PREPARED FOR THE PLAN COMMISSION

Project Address: 1605 Linden Drive
Application Type: Demolition Permit and Conditional Use
Legistar File ID # [40171](#)
Permit Record ID # LNDUSE-2015-00049
Prepared By: Timothy M. Parks, Planning Division
Report includes comments from other City agencies, as noted.

Requested Action: Approval of a demolition permit and conditional use to allow demolition of a former residence known as “Science House” and construction of an addition to Babcock Hall at 1605 Linden Drive on the University of Wisconsin-Madison campus.

DPD Number: **13A2U**
 Job Title: **PR**
 Issue Date: August 11, 2019
 Sheet Number: **C1.00**

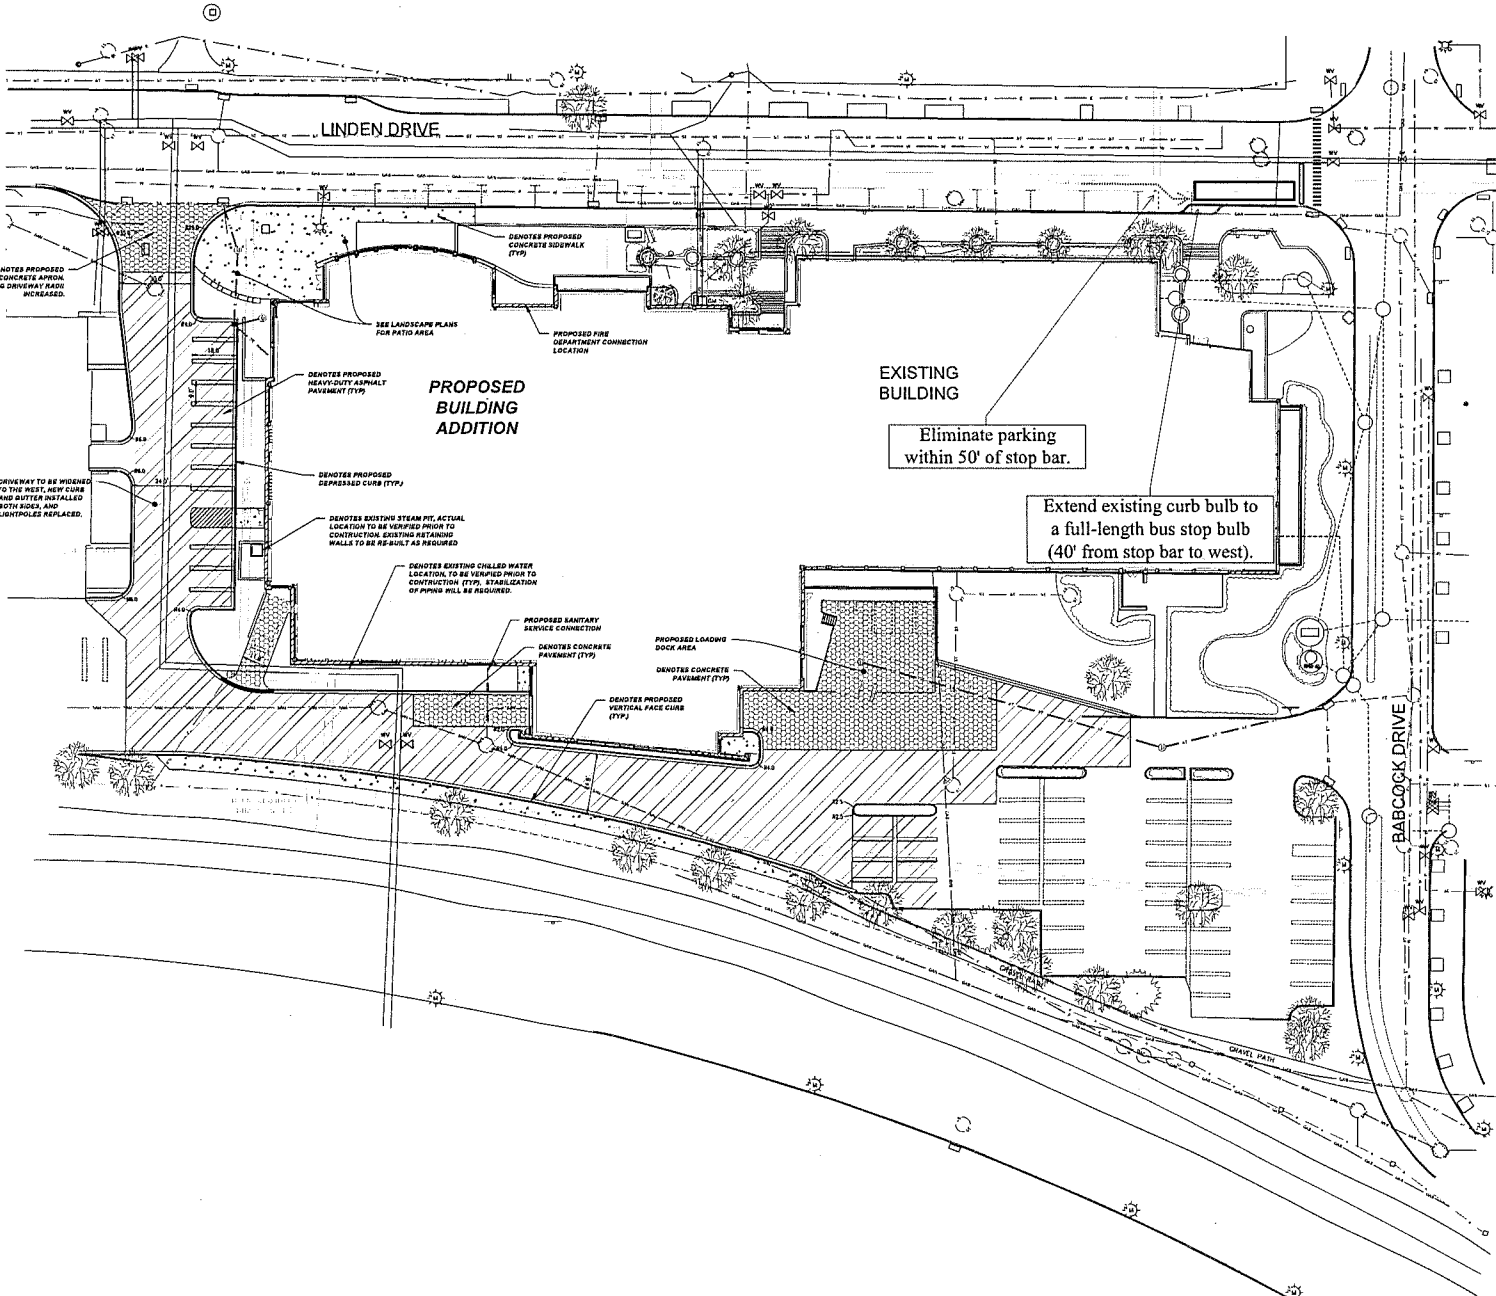
22. Bus stop ID #2003 is adjacent the proposed project site along the south side of Linden Drive, with the bus stop zone encompassing the area from the existing bus stop sign pole back towards the east. The existing parking stall placement is too close to the intersection, which prevents buses from pulling fully adjacent the existing corner bulb to safely load/unload passengers onto the sidewalk terrace from both the front and rear doors, or deploy the wheelchair ramp properly. In coordination with public works improvements, the applicant shall extend the existing curb bulb into a full-length bus stop bulb at the existing Metro bus stop

on the south side of Linden Drive, west of Babcock Drive (#2003). The bus bulb shall measure a minimum of 40 feet in width parallel to the street, running from the existing intersection stop bar to the west.

23. The applicant shall eliminate parking within 50 feet of the existing intersection stop bar, to permit buses to pull fully adjacent the curbside bus bulb loading zone and safely load/unload passengers directly onto the sidewalk terrace - including when deploying the wheelchair ramp. The applicant shall include the location of these transit amenities on the final documents filed with their permit application so that Metro Transit may review and approve the design. [See attached document 1605la_METRO.pdf].

Eliminate parking within 50' of stop bar.

Extend existing curb bulb to a full-length bus stop bulb (40' from stop bar to west).
